**DTC Modification &
Overall Height Modification**

1101 Grundy Street Hotel

Wallace

Downtown Code DRC Meeting of 12/6/2018

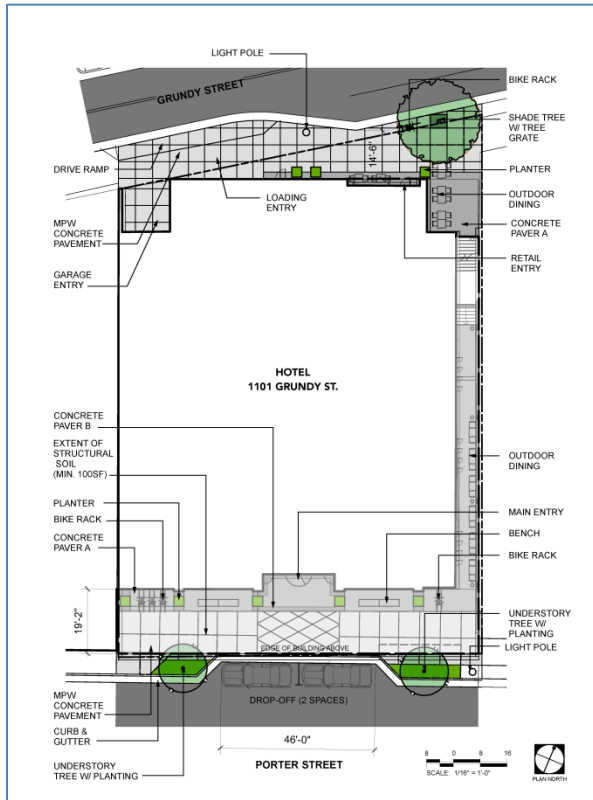
1. Stepback
 - Required: 15 foot minimum stepback is required for buildings 8 stories or greater along public streets between the 4th and 8th stories.
 - Proposed: No stepback is provided along Grundy and Porter Streets in favor of approximately a 15 foot stepback along the east and west facades.
2. Porter Street Build-to Zone
 - Required: The building must be built to within 0-10' along Tertiary Streets.
 - Proposed: The building proposes a 15' Build-to-Zone for the first and second floor along Porter Street.
3. MCSP Porter Street
 - Required: 8 foot clear sidewalk and 4 foot planting strip at back of curb.
 - Proposed: Accommodation for a lay by lane of approximately 6 feet in width with 8 foot clear sidewalk and 4 foot planting strip

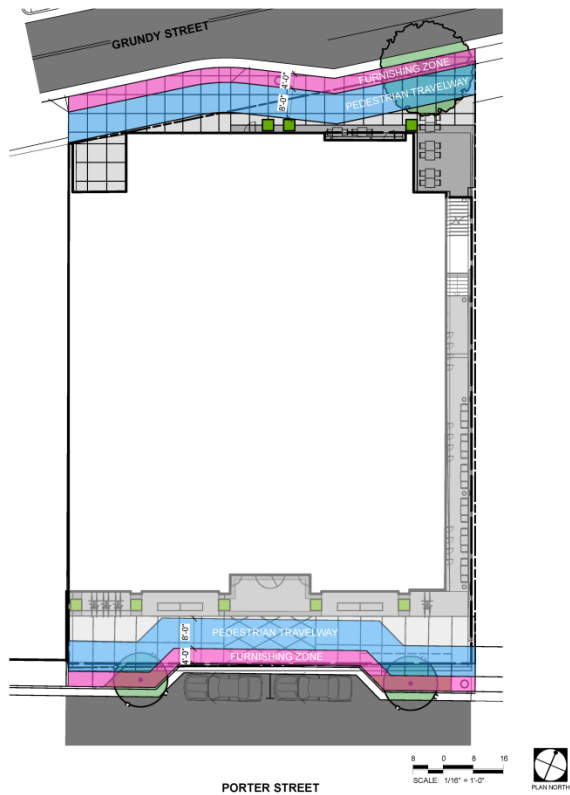
Buildings with storefront frontage along tertiary streets are required to have a 0-10' build-to-zone. The Porter Street entry is recessed 19 feet at the first and second level so that the building cantilevers over an outdoor space.

The remainder of the building, levels 3 through 20, are located at the required build-to line maintaining a consistent street wall and block face along the street. The proposed building recess and cantilever offers a dynamic interaction between the building and the public realm at the ground floor. The outdoor space created by the recess and cantilever offers to enhance the pedestrian experience along Porter Street with high quality material and surface treatment. Furthermore, the recess extends the sidewalk area creating more space for pedestrians to navigate along an already constrained street.
